APPENDIX C

**EPD 10 OCTOBER 2008 REQUEST LETTER
AND UPDATED WATER QUALITY ANALYSIS**

October 10, 2008

ATTACHMENT A
Supplemental Information
Letter from Carol Couch to Colonel Byron Jorns
October 10, 2008

Figure 3
Dissolved Oxygen at Capps Ferry Bridge
2007 Chattanooga River Model Predicted versus 2008 Actual

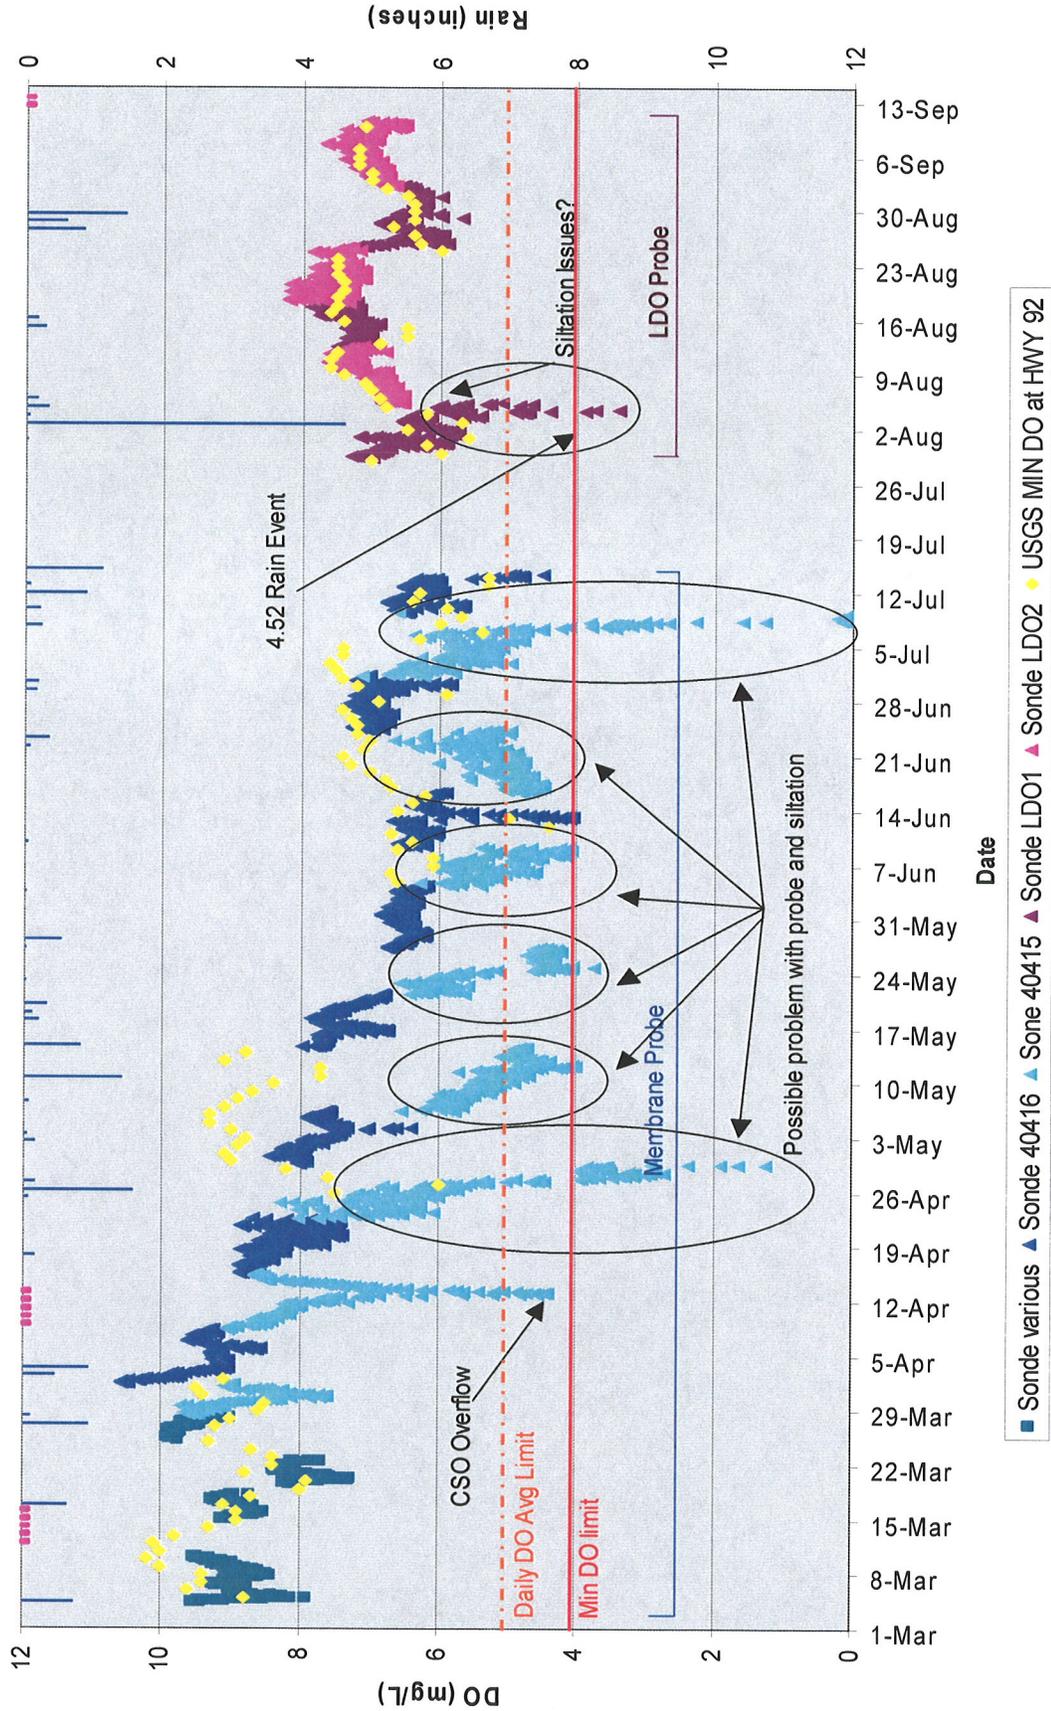
The DO data collected at Capps Ferry and the Fairburn gage generally validate the model results. Figure 3 compares the results of the 2008 DO monitoring at Capps Ferry to the 2007 EPDRIV1 model predictions, excluding unusable data as discussed above. Figure 4 presents the 2007 daily average DO monitoring data from the USGS Fairburn gage and instantaneous readings collected by EPD at the Fairburn gage plotted against the results of the 2007 EPDRIV 1 model predictions at the same location. As shown there is generally good correlation between the actual data and the model at both locations thus validating the model.

Figure 5
Predicted Chattahoochee River Ammonia Concentration Profile
for Minimum Streamflow of 650 cfs at Peachtree Creek

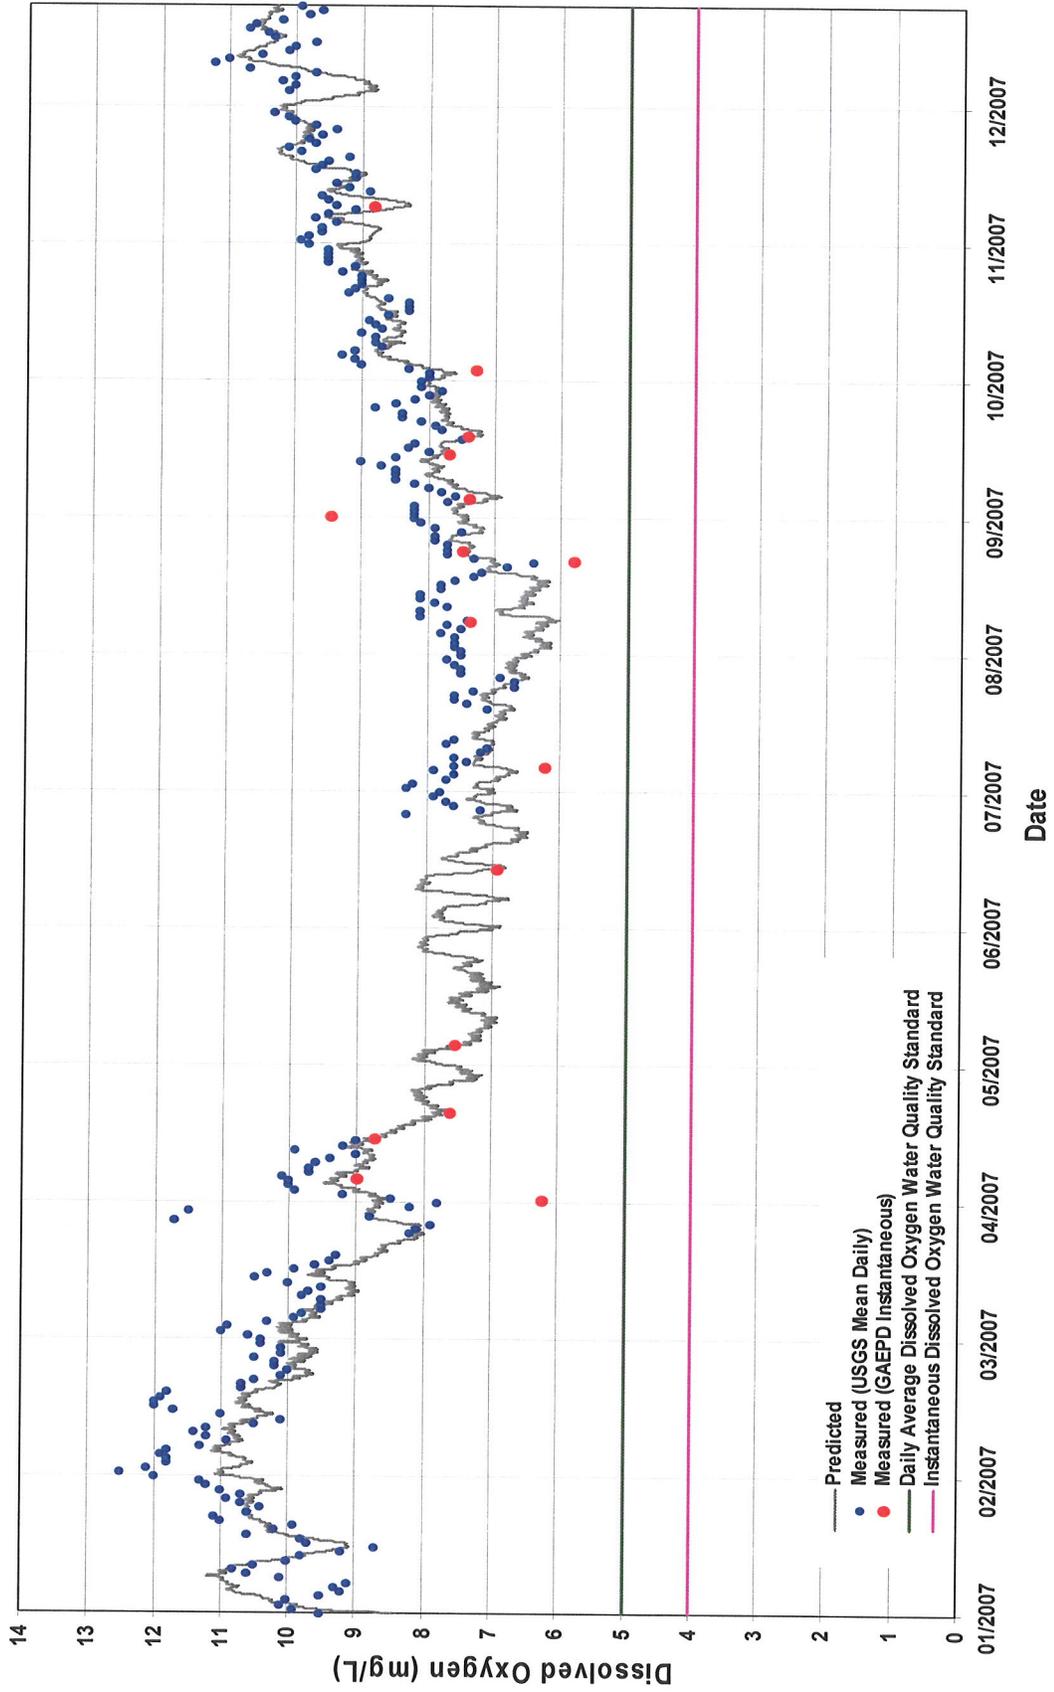
Ammonia Toxicity - In addition to DO, the updated model results also show that the predicted in-stream ammonia concentrations will be far below maximum allowable concentrations. As shown in Figure 5, the model predicts that ammonia concentrations will peak approximately ten miles downstream of Peachtree Creek at the Interstate 20 crossing of the Chattahoochee River. Predicted

Figure 6
Predicted Chattahoochee River Maximum Ammonia Concentrations
for Minimum Streamflow of 650 cfs at Peachtree Creek
(Concentrations are at maximum location.)

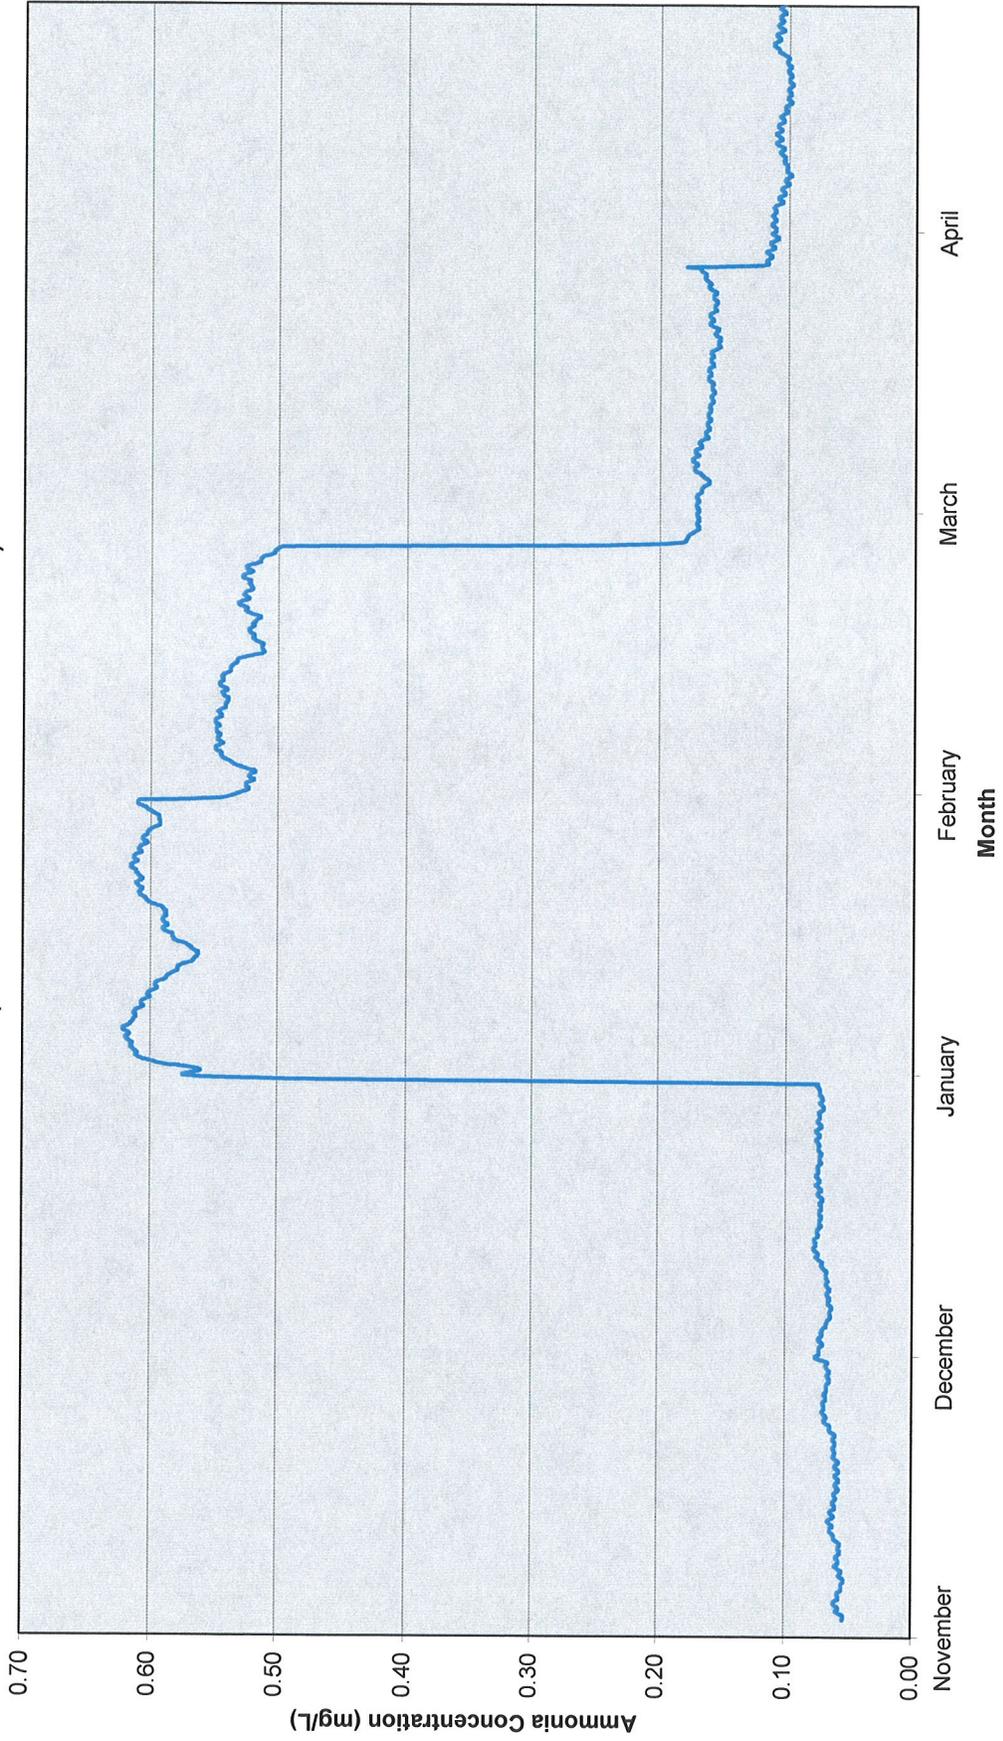
ammonia concentrations at this location are shown in Figure 6 and, in Figure 7, the predicted concentrations are compared to the maximum allowable ammonia concentrations. There is no single number in-stream standard for ammonia; instead the maximum in-stream concentration of ammonia allowed depends upon the temperature and pH of the receiving stream. Figure 7 shows what the model predicts the maximum allowable ammonia concentration would be for selected pH. Variations in the maximum allowable concentration for each selected pH is attributable to in-stream temperature variations. As shown in Figure 7, ammonia concentrations will be substantially below allowable limits.
